Design Overview, Cryostat Penetrations

ETH zürich

01.02.2017

Beam Plug Proposal

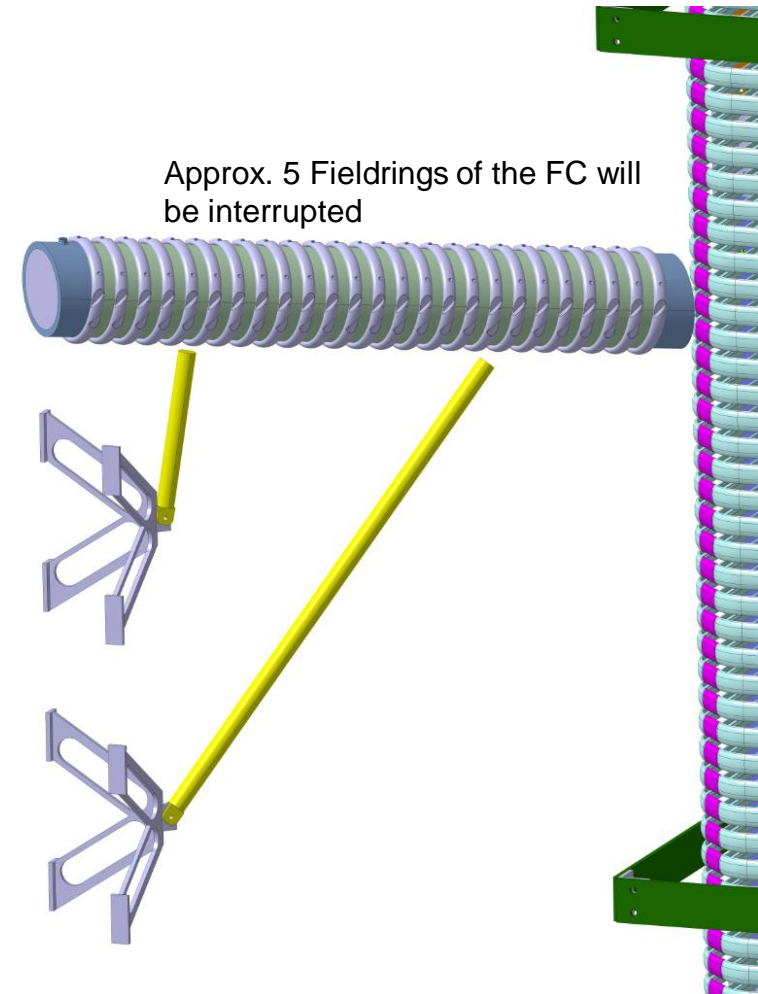
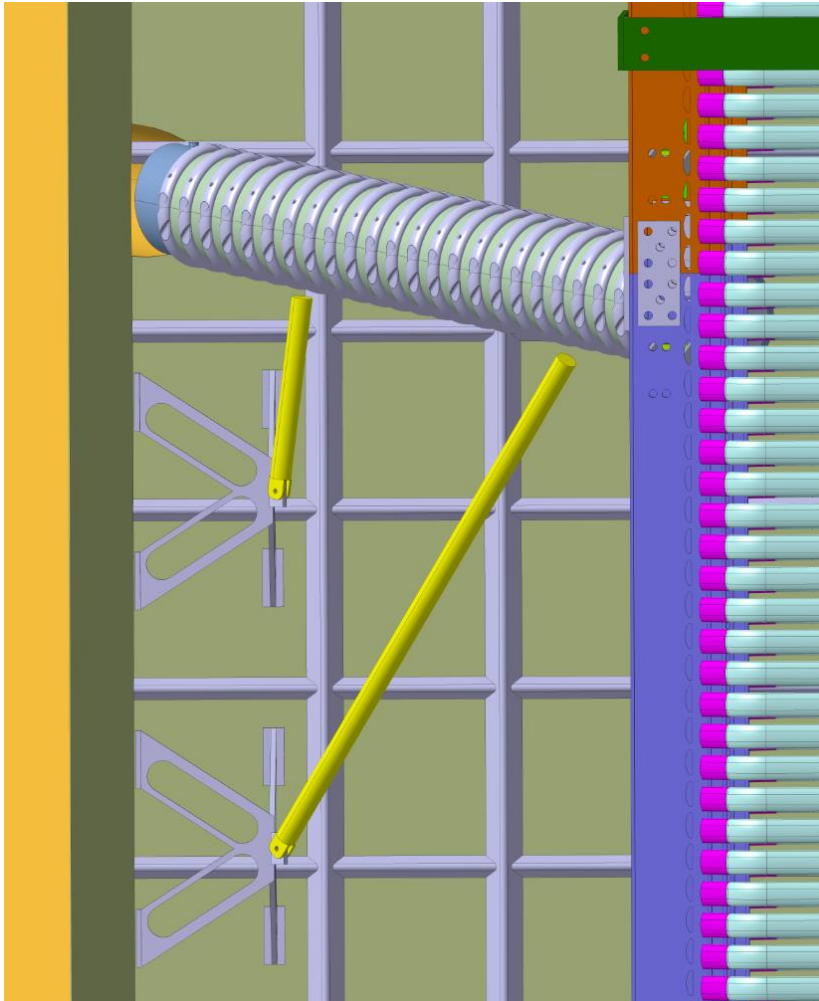
- Supports Points at the Membrane same as for the Internal Piping
- 110 Kg supportet in 8 points at the membrane → ~14 Kg each (Internal pipe ~30kg)
- Still need to be discussed with Marzio
- Length of the Beam Pipe still need to be defined (how much should enter through the Field Cage)

Cryostat Penetrations

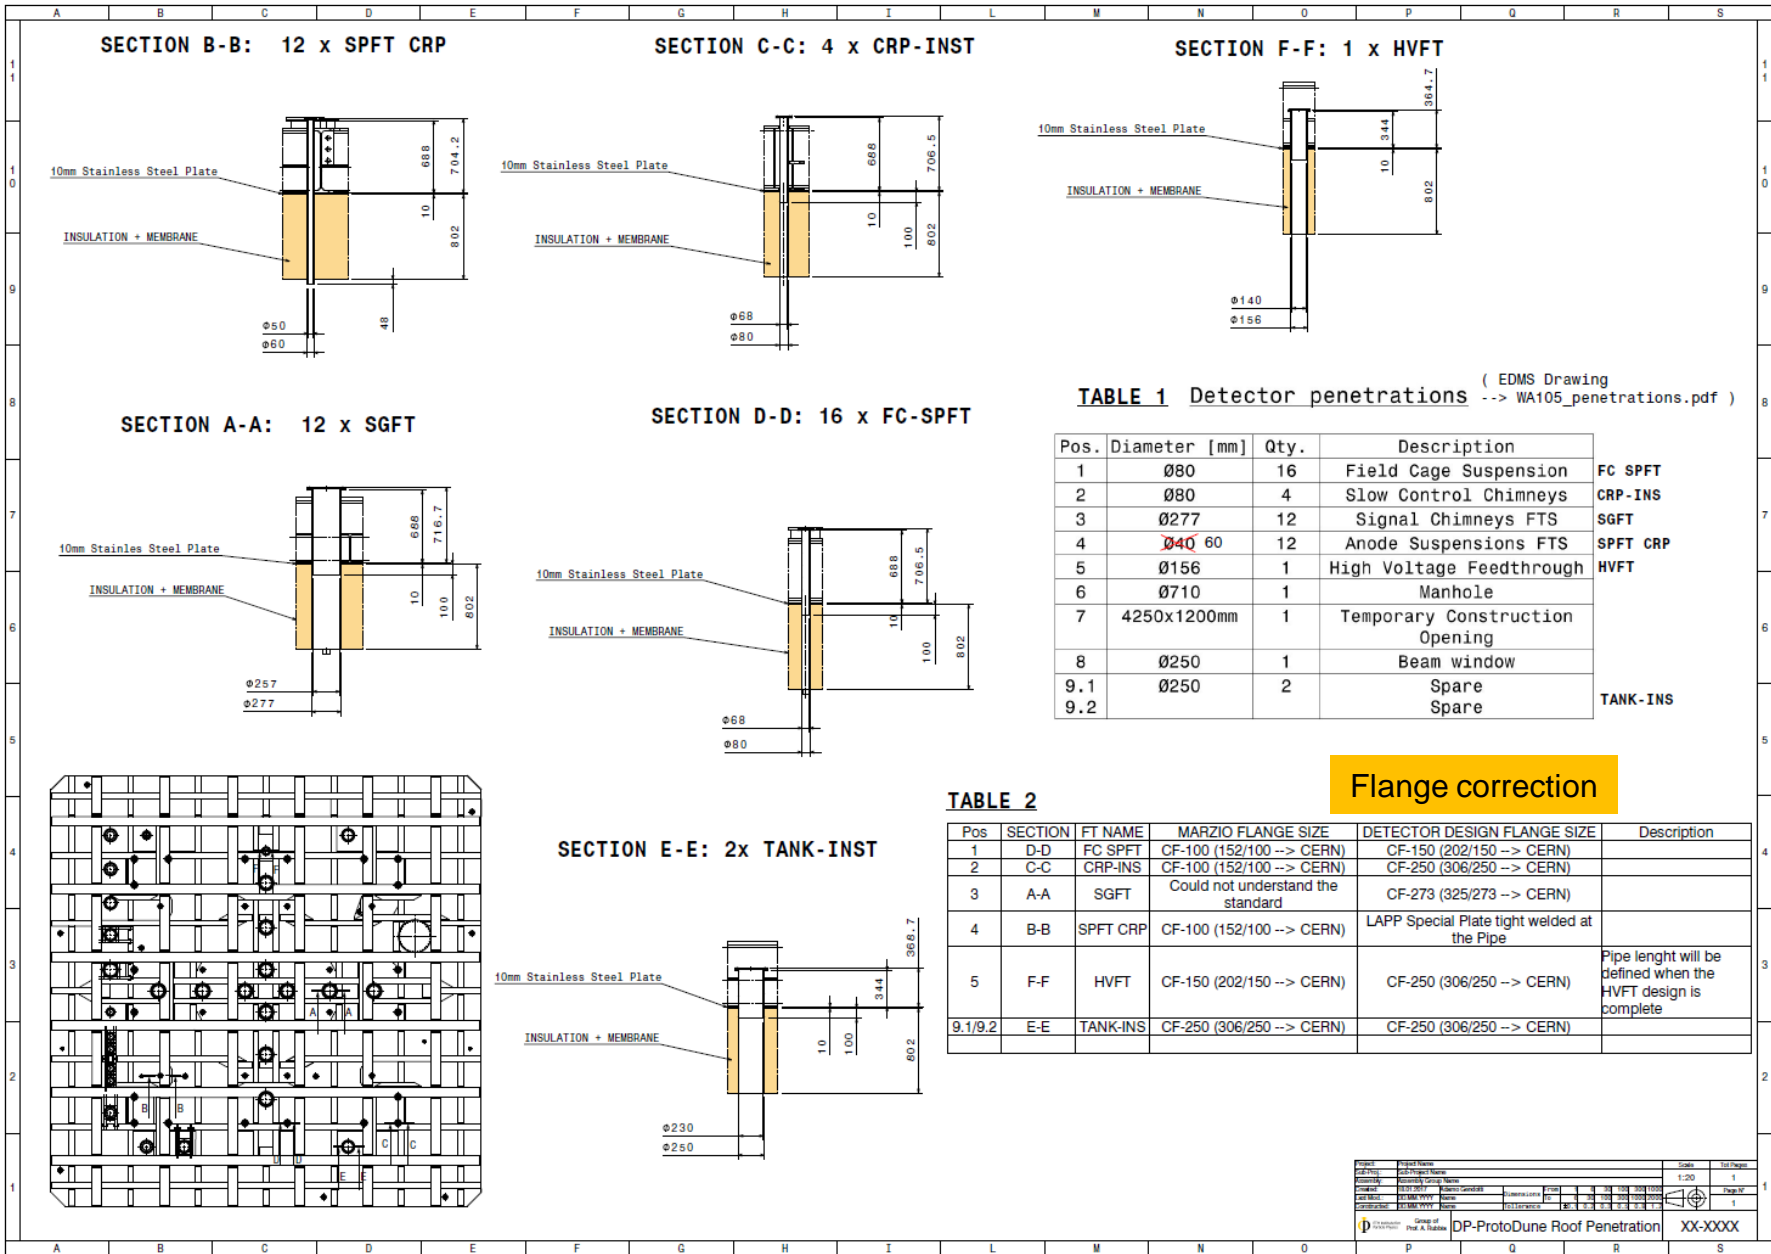
- Length of the Crossing pipes on top of the Cryostat checked OK
- Flange of each Crossing pipes checked → Corrections sent OK
- HV feedthrough → Length of the HVFT Crossing pipe not yet defined

- Anode suspension FTS (position 4, section BD) --> 60 mm
- Slow Control Chimneys (position 2, section CC) --> 80 mm
- HV feedthrough (position 5, section FF) --> the inner diameter should be at least 148 mm

- The signal chimneys FTS (position 3, section AA) Need to reduce the thickness of the pipe in order to gain 2mm
- Tank instrumentation FTS (positions 9.1, 9.2, section EE) OK
- Field cage suspension (position 1, section DD) OK
